Access Compliance Report Public Rights-of-Way (Curb Ramps)

Intersection ID: 14028 Main Street: JAMES_ST **Cross Street: WEST BV** Location: NE ADA ID: 9ECDC8937890 Ramp Type: PerpDiag Initial Pass/Fail: Fail **Overall Compliance: No** Severity Score: 33.75

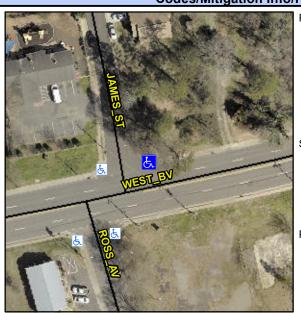
Possible Solutions: Remove & Replace Curb Ramp With **Two New Directional Ramps or** Equivalent. Surveyor Notes: N/A PROW/ADA: Not Found, R304.5.1, R304.5.3

Field Measurements/Component Compliance					
Compliance Description		Data	Comp	liance Description	Data
N/A	Ramp Length (in)	50.0	Yes	Ramp Slope (%)	5.4
No	Ramp Width (in)	43.0	No	Ramp XSlope (%)	12.7
N/A	Flare Type LT	N/A	N/A	Flare Type RT	N/A
N/A	Flare Slope LT (%)	N/A	N/A	Flare Slope RT (%)	N/A
N/A	Flare Traversable LT?	N/A	N/A	Flare Traversable RT?	N/A
N/A	Landing Length (in)	N/A	N/A	DWS Provided?	N/A
N/A	Landing Width (in)	N/A	N/A	DWS Contrast?	N/A
N/A	Landing Slope (%)	N/A	N/A	DWS Length (in)	N/A
N/A	Landing X Slope (%)	N/A	N/A	DWS Full Width?	N/A
N/A	Landing Curb? (Y/N)	N/A	N/A	DWS Offset (in)	N/A
N/A	Shared Landing?	N/A			
N/A	Gutter Ponding?	N/A	N/A	Gutter Slope (%)	N/A
N/A	Gutter Lip Ht (in)	N/A	N/A	Gutter X Slope (%)	N/A
N/A	Painted X Walk1?	No	N/A	Painted X Walk2?	No
	X Walk 1 Direction	To W		X Walk 2 Direction	To S
N/A	X Walk 1 Width (in)	N/A	N/A	X Walk 2 Width (in)	N/A
	X Walk 1 Slope (%)	3.1		X Walk 2 Slope (%)	15.0

X Walk 1 X Slope (%)	8.2		X Walk 2 X Slope (%)	5.7
N/A	Ramp inside XWalk1?	N/A	N/A	Ramp inside XWalk2?	N/A
	Road Slope (%)	8.0	N/A	Clear Space?	N/A
	Road X Slope (%)	5.7	N/A	Clear Space to XWalk (in)	N/A
N/A	Any Obstructions?	N/A	N/A	Storm Grate/Utility Hazard?	N/A
	Obstruction Type			Storm Grate/Utility Type	
		N/A			N/A
			Yes	Surface Condition? (G/P)	Good
